**SUBJECT: LETTER OF NOTIFICATION FOR A 10CFR21 REPORTABLE
CONDITION**

Reference: Foxboro Model No. N-E13DM-IHM2
or Spare Part No. N0141FN

RE: Weed Model N-E11 & N-E13 Pressure/DP Transmitters
10CFR21 Notification

Figure No. 1

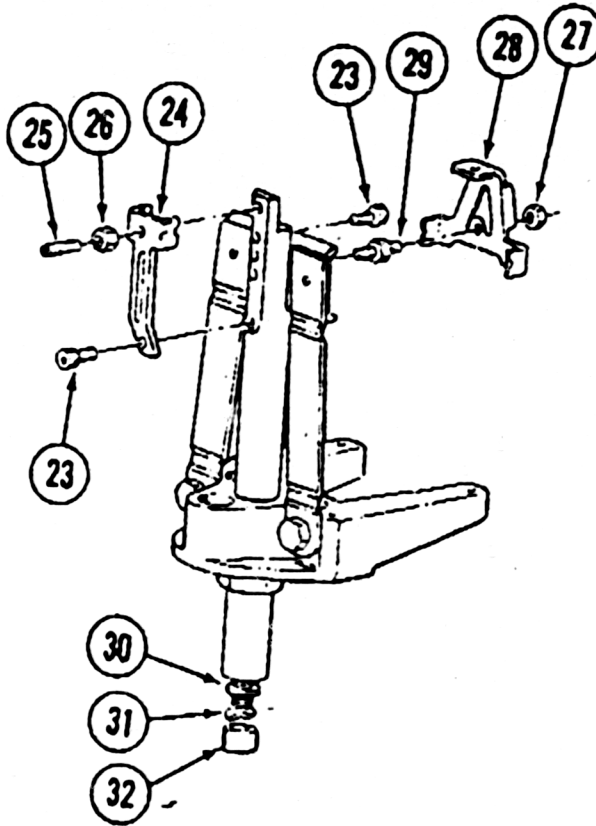
In compliance with 10CFR Part 21.21(a)(1)(ii), this letter is to notify you that we may have shipped you either a transmitter with an improperly processed part and/or the part itself. The subject part is Part No. N0141FN, a bracket, and is identified as number 24 in the attached Figure No. 1. The bracket is located in the transmitter topworks at the top of the force bar assembly and provides topworks static alignment and overrange protection. In August of 1989 the bracket material was changed to a 410SS, which requires a two step heat treating process, instead of a single step process, for proper material characteristics. The correct process change was not implemented until Jan.-Feb. 1990. Single step heat treatment of 410SS allows cracks to form near the bracket mounting hole and from which the cracks will continue to propagate, thus weakening the bracket. This discrepancy was discovered only very recently. Weakening brackets may cause one of the following to occur:

- a. Zero Drift and/or Span Drift in the downscale direction
- b. Static Alignment Errors Unable to Realign (DP's only)
- c. Excessive Calibration Non-linearity (>1%) Zero or Elev/Supp Ranges
- d. Inability to adjust from a Zero Based Range to a Suppressed Range Calibration (Using an Elev/Supp Bias Kit)
- e. Greater than normal Overrange Errors

Visual inspection will not reveal the existence of cracks because of bracket painting but different bracket finishes do identify suspected or faulty processed brackets. Unfinished/unpainted brackets and brackets with a "Gray" painted finish must be replaced. Brackets with a "Silvery" finish similar to the finish on the "Forcemotor" are correctly processed and replacement is not necessary.

In compliance with the requirements of NRC 10CFR21, this letter provides notification that Weed Instrument may have supplied you with an improperly processed part. The component is a bracket (P/N N0141FN), located in the transmitter's topworks and attached to the force bar assembly (see Figure No. 1, attached).

No instrument failure due to the bracket is expected, but we do agree with Foxboro Company that a weak bracket could lead to calibration drift in the downscale direction, calibration non-linearity, overrange errors, and/or suppressed range calibration problems. The bracket interacts with the static alignment, overrange protection, and transfers the movement of the force bar to the force balance motor.

Use of applicable Foxboro Master Instructions (MI's) will be required to properly align the specific transmitter after bracket installation. It is recommended that only personnel trained in Foxboro Transmitter servicing should perform bracket replacement and transmitter re-alignment. Replacement brackets 24 include screw 25 and locking nut 26 as in Figure No. 1, attached. The mounting screw 23 can be re-used for bracket replacement.
